### Memorandum to the City of Markham Committee of Adjustment March 12, 2021

File:	A/005/21
Address:	18 Grenfell Crescent – Markham, ON
Applicant:	Hetal Peshavaria
Agent:	Memar Architects
Hearing Date:	March 24, 2021

The applicant is requesting relief from the following "Residential One (R1)" requirements under By-law 1229, as amended, as they relate to a proposed two-storey detached dwelling. The variances requested are to permit:

### APPENDIX "C" ARBORIST REPORT AND TREE PRESERVATION PLAN

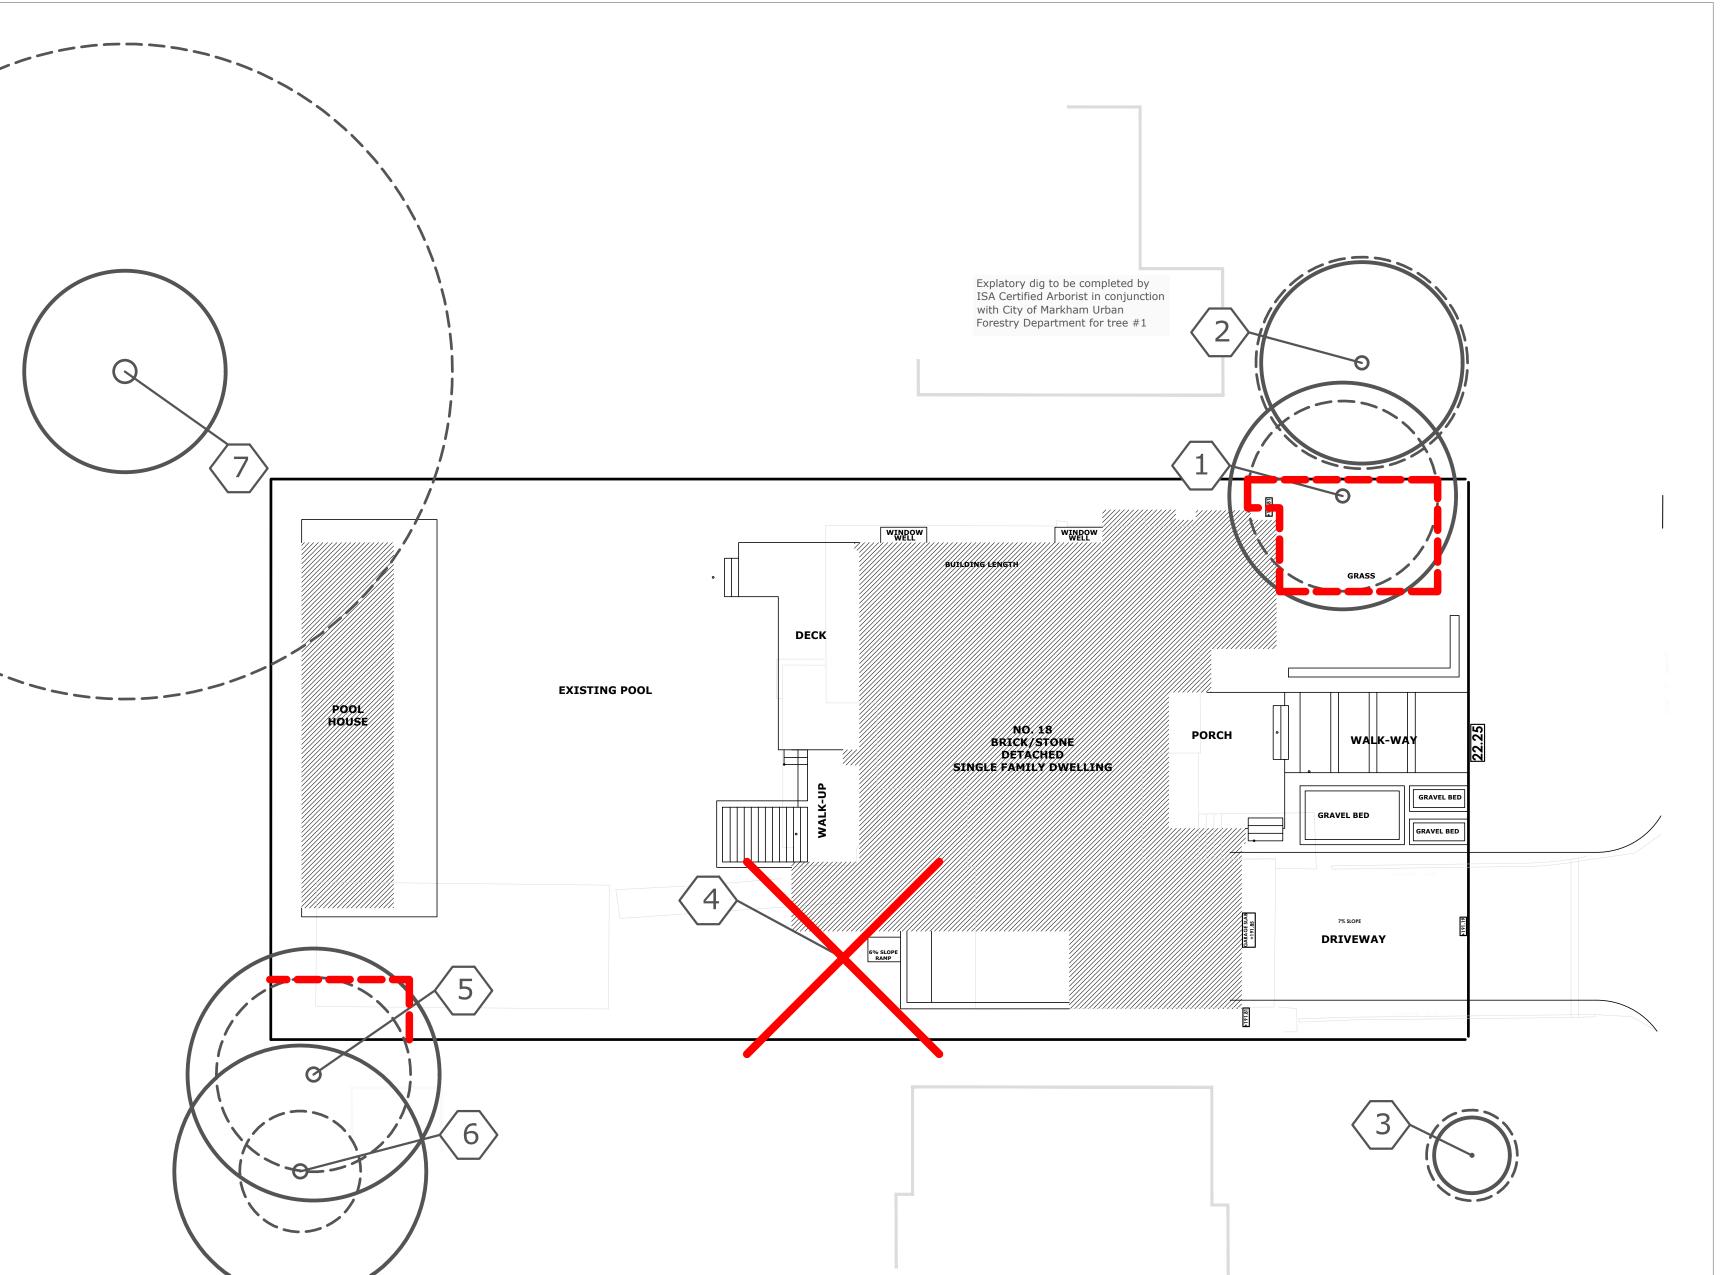
The applicant submitted an Arborist Report and Tree Preservation Plan dated March 10, 2021 which confirms a total of two trees on the subject property, one of which is a White Spruce tree located in the front yard, and the other is a Honey Locust in the rear yard (Appendix "C"). The applicant has worked with staff to shift the dwelling to lessen any impact to the White Spruce tree located in the front yard.

Staff are of the opinion that the protection of the Honey Locust tree located in the front yard will assist in softening the appearance of the dwelling, and recommend that the Committee adopt the tree related conditions provided in Appendix "A" in the event of approval to ensure the applicant provides adequate tree protection and compensation in accordance with the City's Streetscape Manual. Operations staff note that the cedar
